### **AMENDMENTS TO THE DRAWINGS**

The attached sheets of drawings include changes to the drawings. These sheets, which include Figures 1-4, replace the original sheets including Figures 1-4.

FIG. 2

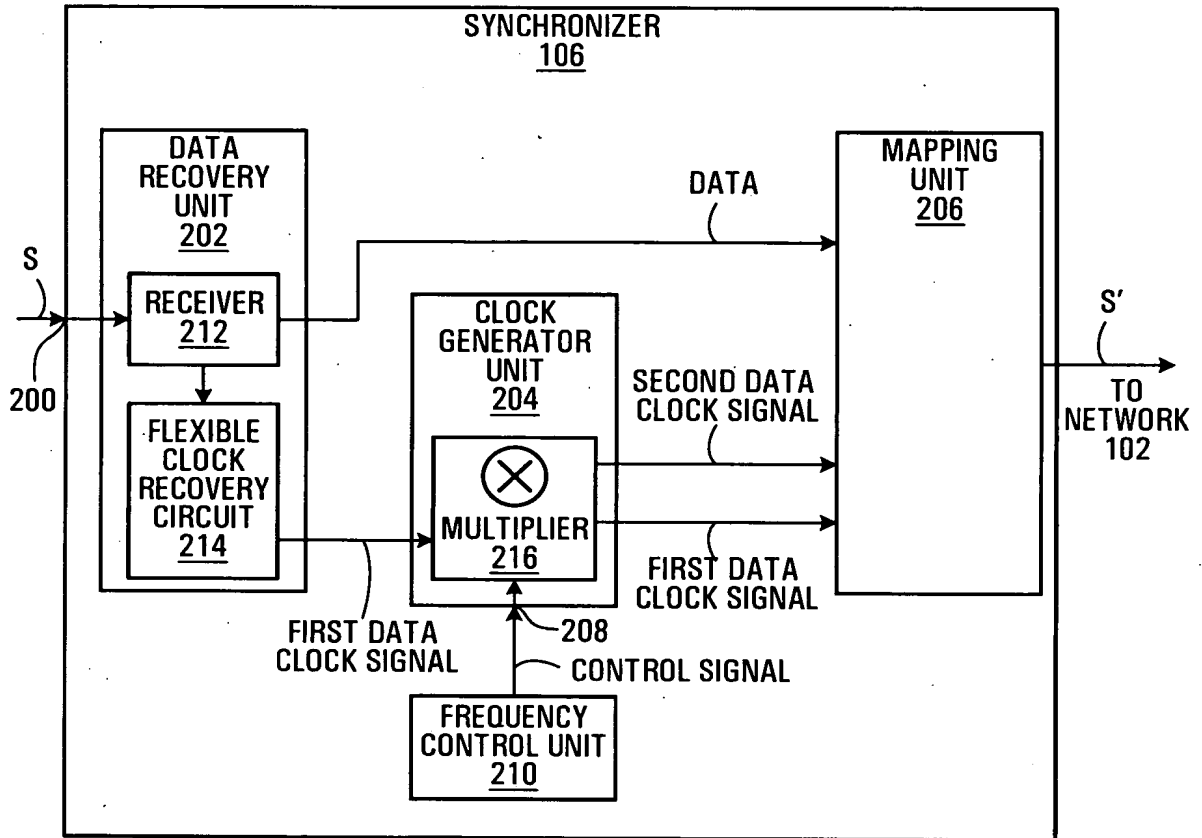
In Figure 2, the clock generator unit 204 has been labeled as such. In addition, the reference number of the multiplier has been changed from "206" to "216".

In Figures 2-4, labels "CLK2" and "CLK" have been replaced with the label "second data clock signal", and the label "CLK1" that appeared in Figures 2-3 has been replaced with the label "first data clock signal".

FIG. 3

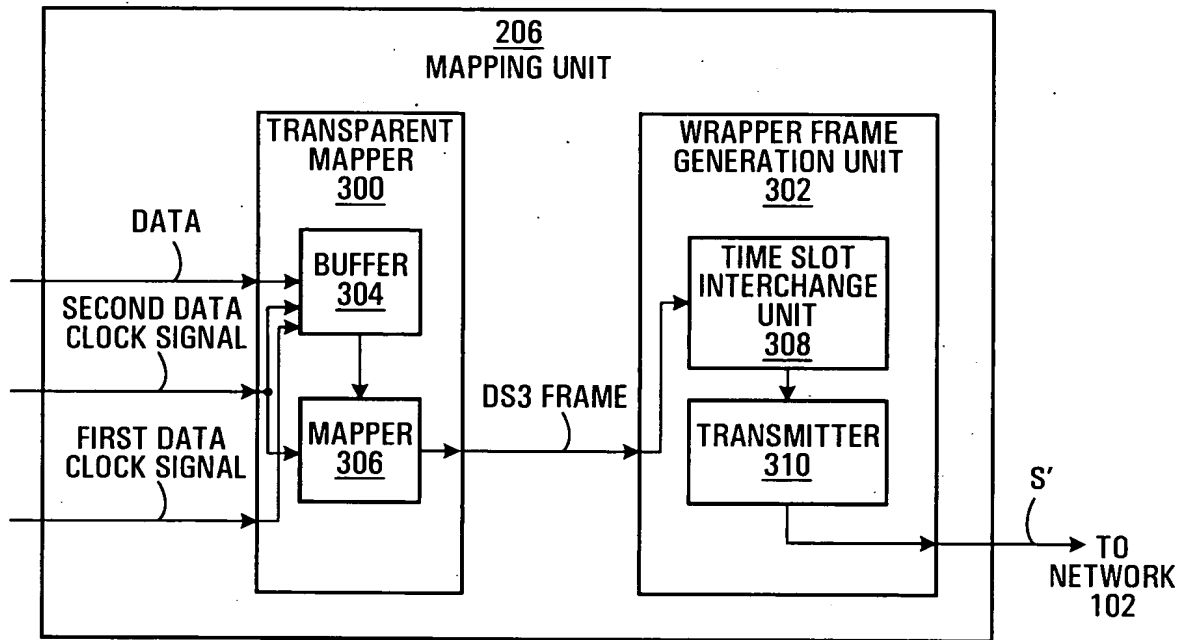
In Figure 3, specific inputs to functional elements 304 and 306 are now shown, as described in the specification. In Figure 4, specific inputs to functional elements 412, 414 and 416 are now shown, as described in the specification.
